***Unitary Products
Technical Services
Service Letter***

Letter: **YS-001-2018**

Subject: Update on 14 SEER – 4 & 5 ton Compressor Suction Tube Issue

Product: YHE48/TH4B48/RHPL14L48 and YHE60/TH4B60/RHPL14L60 Heat Pumps

New Tubing Arrangement (shown in red)

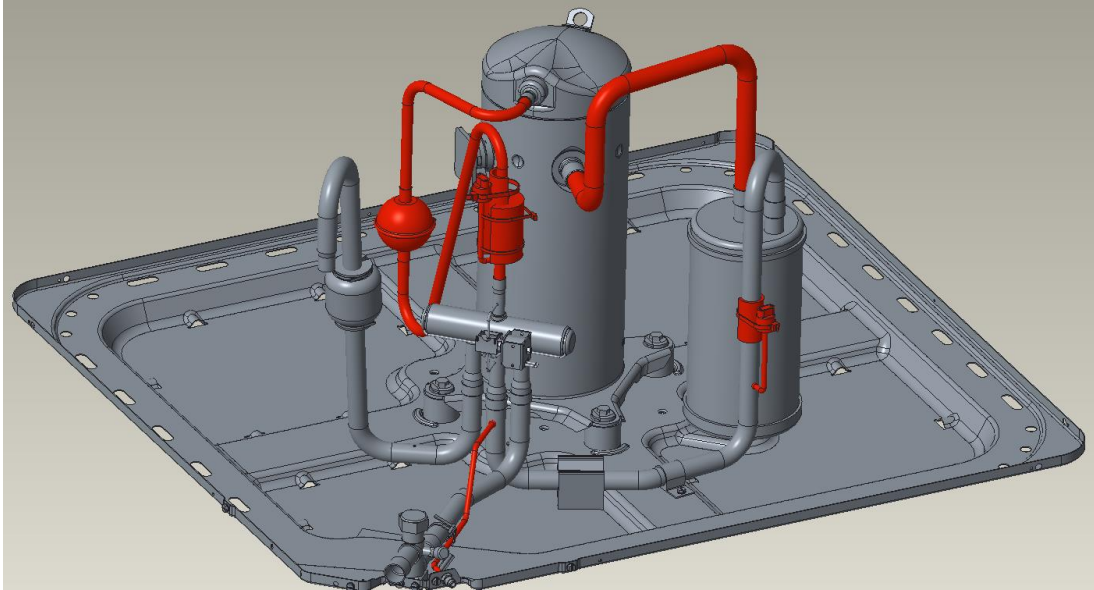
In follow up to ST-011-2017 and R letters (R-185 through R-191) the solution to this issue is now complete, and production of these models restarted the week of December 18, 2017. The solution involved design changes to (4) tubes within the outdoor unit. We have attached CAD drawings of both the old and new tube designs to help you identify the changes. Keep in mind that you can also identify the new design by the production date code of W1N7xxxxxx (December 2017) and more specifically by the generation change (-21S to -22S).

New suction and discharge tubes, new location of pressure switches and field process line.

Old Tubing Arrangement (shown in blue)
